### Typ 1, 4+4+3+PE

7.084.944.101 / 7.084.944.102

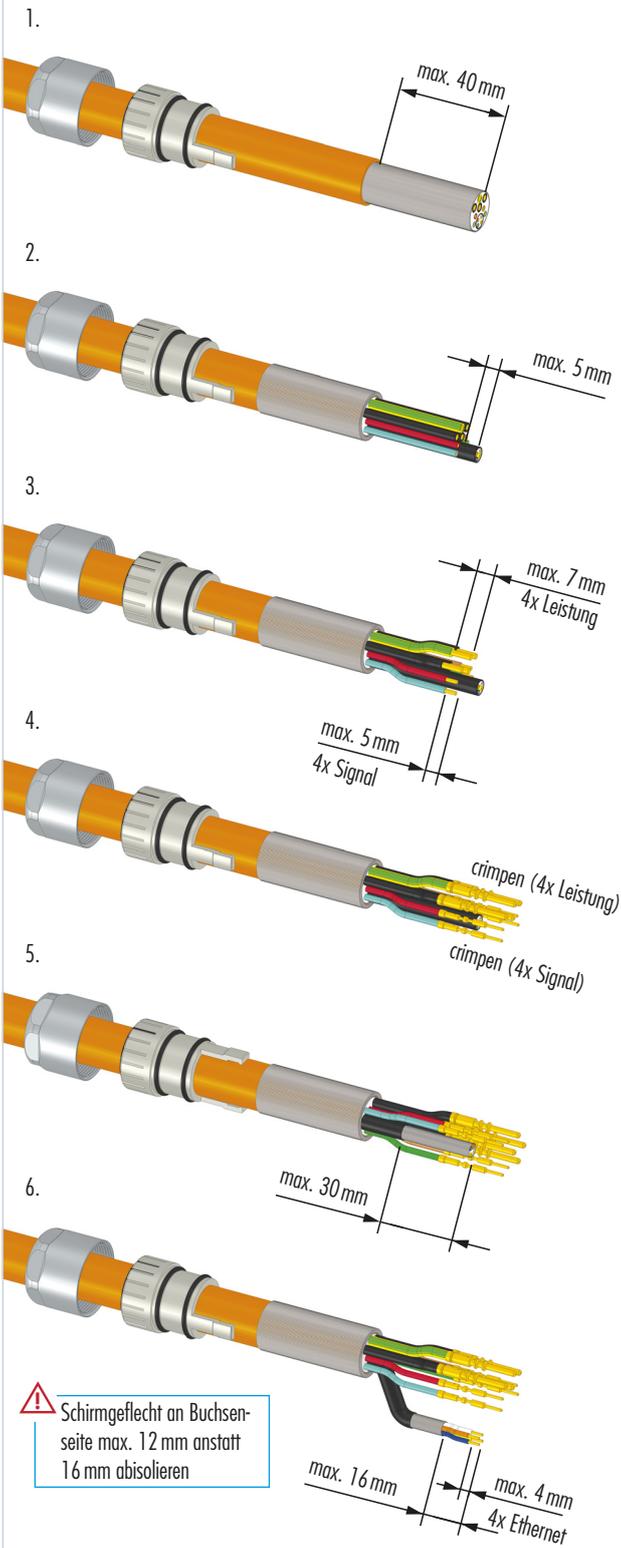
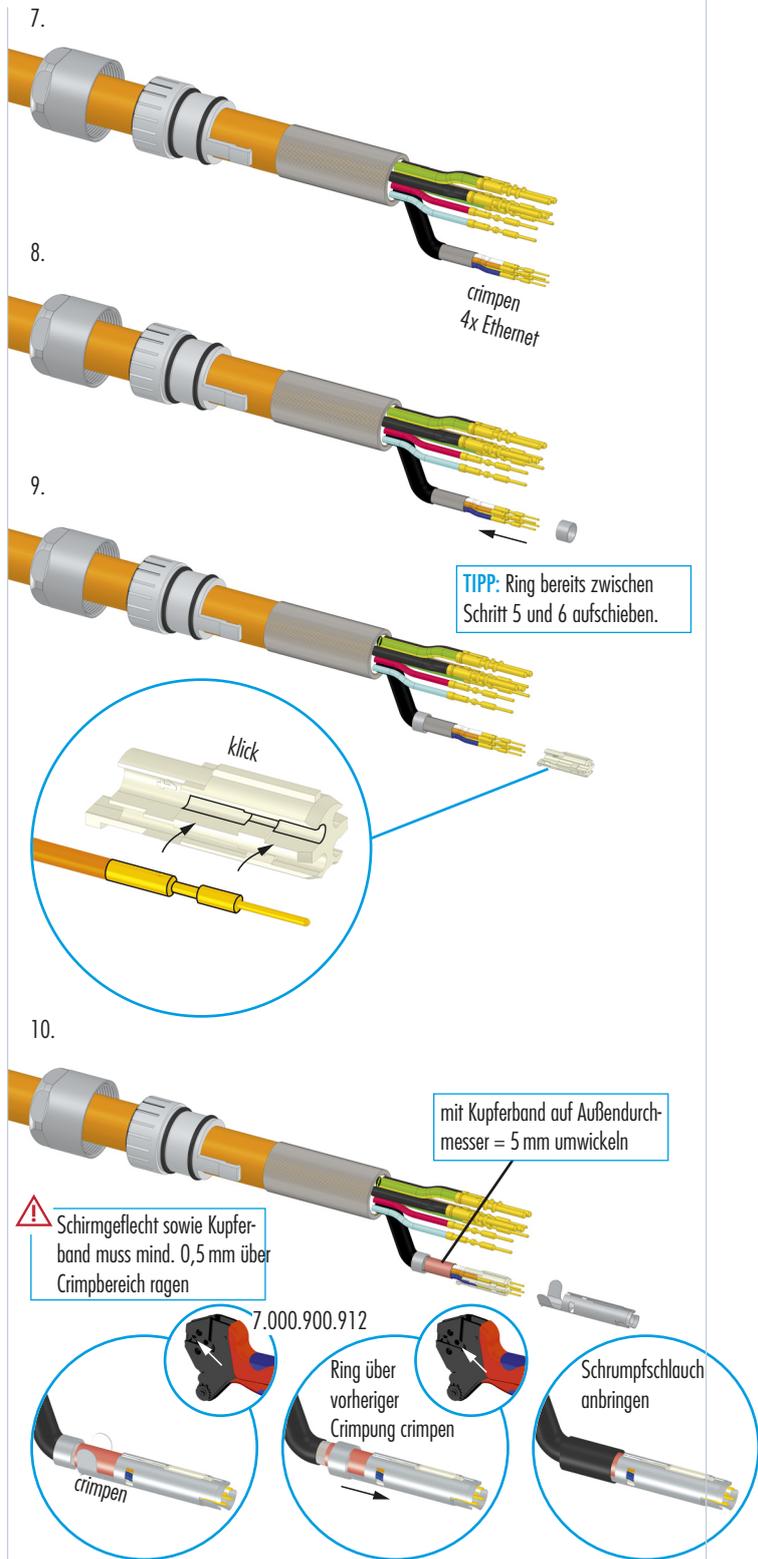
⚠ Schirmgeflecht an Buchsen-  
seite max. 12 mm anstatt  
16 mm abisolieren
